DAILY REPORT NO: 015

Site Visit: Friday, September 12, 2012 (10:30am to 12:45pm)

The purpose of this visit was to survey the G line units regarding the progress and quality of workmanship of construction.

Inadequacies: Laundry room inadequate lighting.

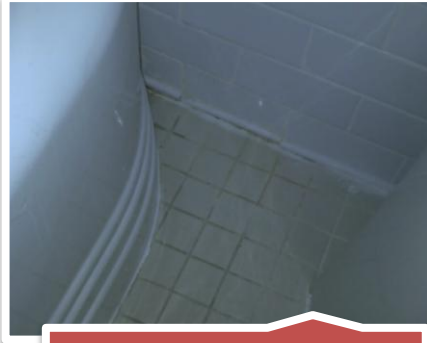
Upon my visit to the property a representative from the company to provide and install washers and dryers was present at the site. According to the representative the plan is to install six (6) washers and six (6) gas powered stackable dryers. In consideration of this plan it is my opinion that the number of washers and dryers is extremely deficient for the total number of units in the building. Based upon general design standards one washer and dryer should be installed for every eight (8) to ten (10) family apartments. In addition the current room is inadequately lighted and the air is stagnant.

- Allow a minimum of 25 square feet per machine.
- Provide a minimum clearance of 8' between floor and overhead pipes
- Locate dryers on exterior building walls. Long ducts increase installation costs and are less effective for proper venting.
- Provide sufficient lighting. Fluorescent lighting provides 2 ½ times the lumens obtained from incandescent lighting (i.e. a 40 watt fluorescent is equal to a 100 watt incandescent). This is extremely important because the laundry room is secluded and there needs to be a high sense of safety.
- Provide adequate ventilation and air flow to alleviate the current and further stagnant air in the room.
